ONSITE SEWAGE DISPOSAL SYSTEM

P 559855

SEWER HOUSE CONNECTION

PROPERTY ADDRESS: 7021 Deer Valley Rd.

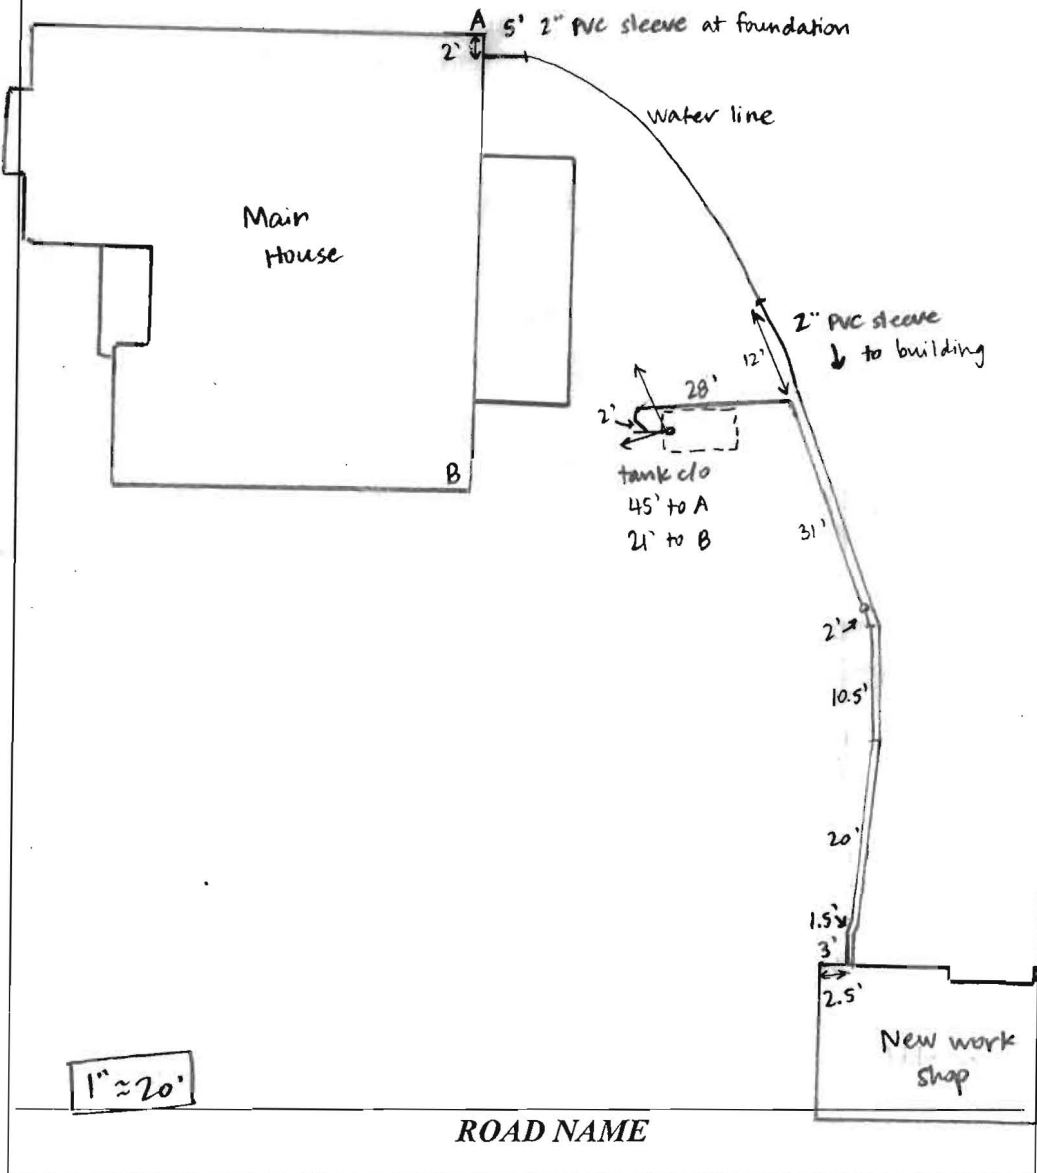
INSTALLATION: 2/3/17 Contractor completed sewer line tie-in from new work shop. 4" PVC, adequate fall in line. Water line is in same trench as sewer line - need sleeve on water line when it's within 10' of sewer line. Water line also needs 5' sleeve at house foundation. 2/3/17 2" PVC sleeve installed on water line from within 12' of joining sewer line in trench to new work shop. 5' sleeve installed at house foundation. (50)
